Designing Toronto's Future Streets Consultation Process

A Report on the Public Consultation Process for the Development Infrastructure Policy and Standards (DIPS) Review

NOVEMBER 2005

Streetscape #4

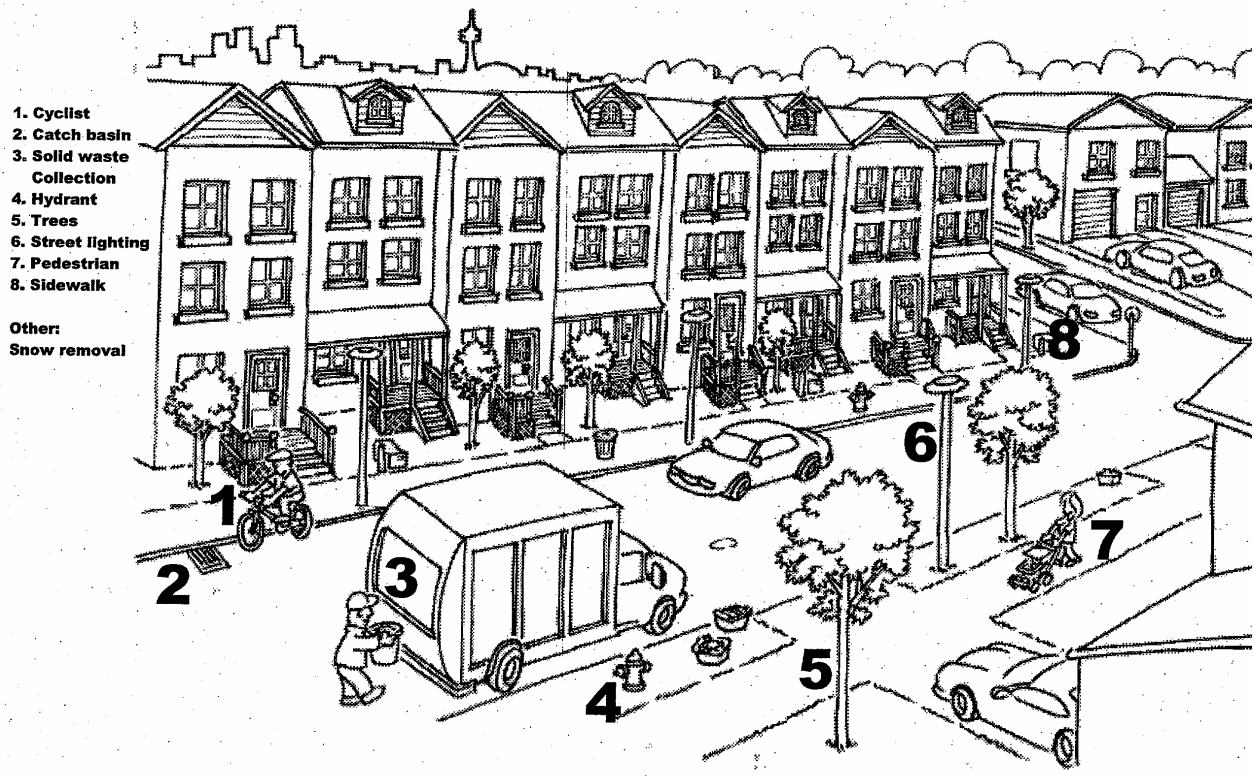
The fourth and final streetscape stirred a considerable amount of emotion amongst workshop participants. Initial verbal reactions to this streetscape included "alienating", "cold", "barren", "inhospitable" and "uninviting" (comments received mainly by participants at the Toronto & East York and Etobicoke York workshops). However it should be noted that not all participants responded in this manner. Some participants (mainly in the Scarborough and North York districts) felt this streetscape offered a good 'quality of life'.

The most frequent 'likes' included the width and location of the sidewalks, the inclusion of a boulevard with trees and the wide ROW. Again, sidewalks on both sides of the street were a common preference amongst workshop participants.

The most common 'dislikes' expressed were the ROW (which was deemed too wide) and the pavement width (again considered to be too wide). It was felt that the pavement width encouraged speeding and was a waste of space.
